UNITED STATES PATENT AND TRADEMARK OFFICE

10/695,011

Office Action Summary	Application No.		Applicant(s)	
	10/695,011		BAUER, VAUGHN L.	
	Examiner		Art Unit	
	Victor Batson		3671

FIG. 3

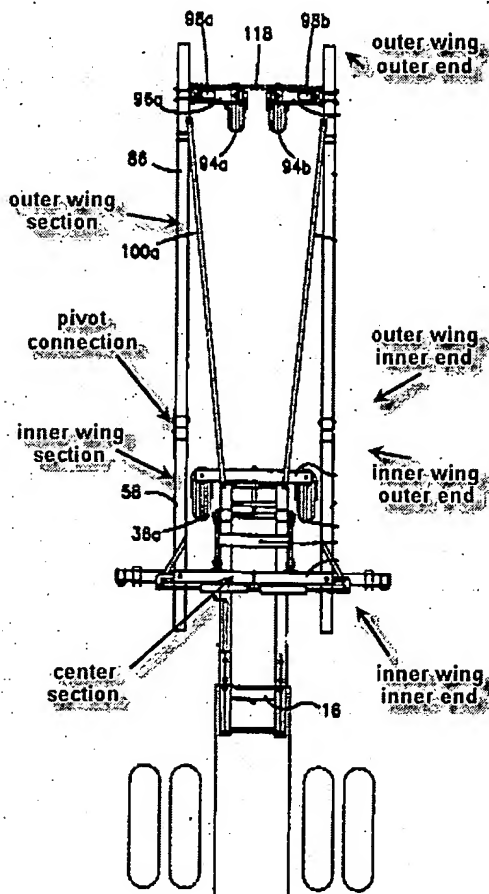
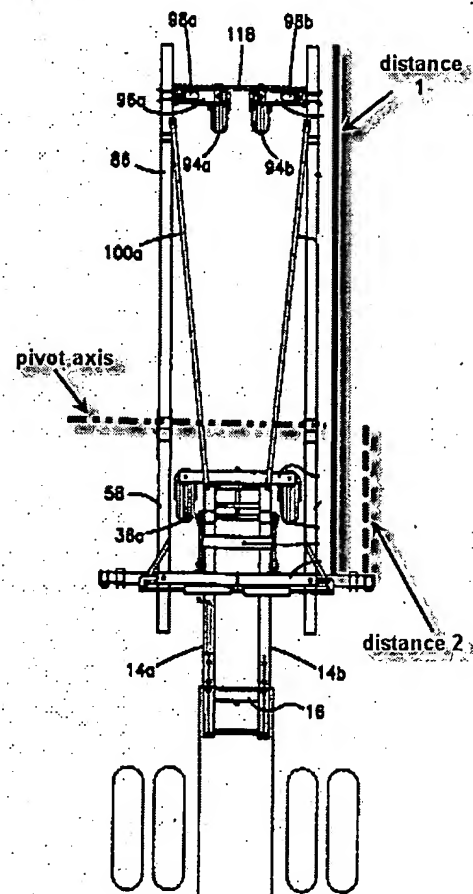
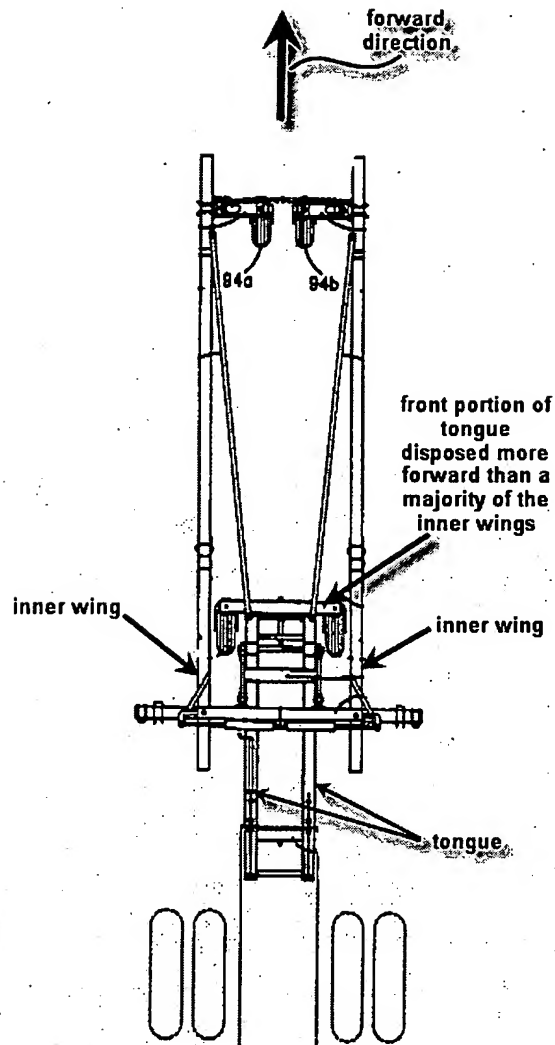
Kirwan discloses a forwardly folding toolbar comprising a tongue, a center section, outer wing sections, inner wing sections, with a distance between the outer end of the outer wing section and the inner end of the inner wing section greater than a distance between the inner end of the outer wing section and the inner end of the inner wing section. Concerning the method claims, given the structure of Kirwan, the claimed

method steps would inherently be performed while the device of Kirwan was assembled and operated. The examiner notes that since part of the tongue of Kirwan is disposed forward of a majority of the inner wings (as set forth in the modified figure below), Kirwan is considered to meet the limitation of the tongue being disposed more forward than the wing sections.

distance 1 > distance 2
